Access Compliance Report Public Rights-of-Way (Curb Ramps)

Main Street: ARTISAN_ST **Cross Street:** WYETH_ST **Location:** W

ADA ID: RPRK211020164611 **Ramp Type:** Type 4 - Parallel **Initial Pass/Fail:** Fail **Overall Compliance:** No **Severity Score:** 15

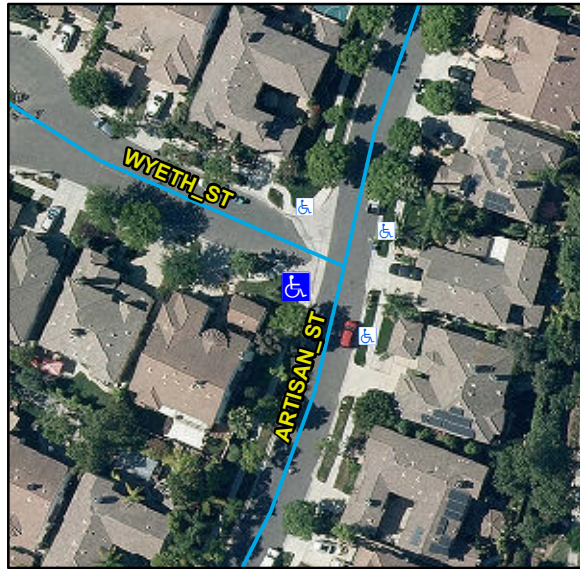
Compliance	Description	Data	Compliance	Description	Data
N/A	Ramp Length LT (in)	108	N/A	Ramp Length RT (in)	114
Yes	Ramp Width LT (in)	53	Yes	Ramp Width RT (in)	54
Yes	Ramp Run Slope LT (%)	5.7	No	Ramp Run Slope RT (%)	10.1
Yes	Ramp Cross Slope LT (%)	0.9	Yes	Ramp Cross Slope RT (%)	0.2
N/A	Landing Present	N/A	N/A	DWS Provided	N/A
N/A	Landing Length (in)	N/A	N/A	DWS Contrast	N/A
N/A	Landing Width (in)	N/A	N/A	DWS Length (in)	N/A
N/A	Landing Run Slope (%)	N/A	N/A	DWS Full Width	N/A
N/A	Landing Cross Slope (%)	N/A		DWS Offset Type	N/A
N/A	Landing Movement Obstructed?	N/A	N/A	DWS Offset Left (in)	N/A
	Landing Movement Type	N/A	N/A	DWS Offset Right (in)	N/A
N/A	Landing Shared	N/A			
N/A	Clear Space	Yes			
N/A	Clear Space To Crosswalk (in)	N/A			
N/A	Marked Crosswalk 1	No	N/A	Marked Crosswalk 2	No
	Crossing 1 Direction	SE		Crossing 2 Direction	NE
N/A	Marked Crosswalk 1 Width (in)	N/A		Marked Crosswalk 2 Width (in)	N/A

Possible Solutions:
Remove & Replace Curb Ramp With Two New Directional Ramps or Equivalent.
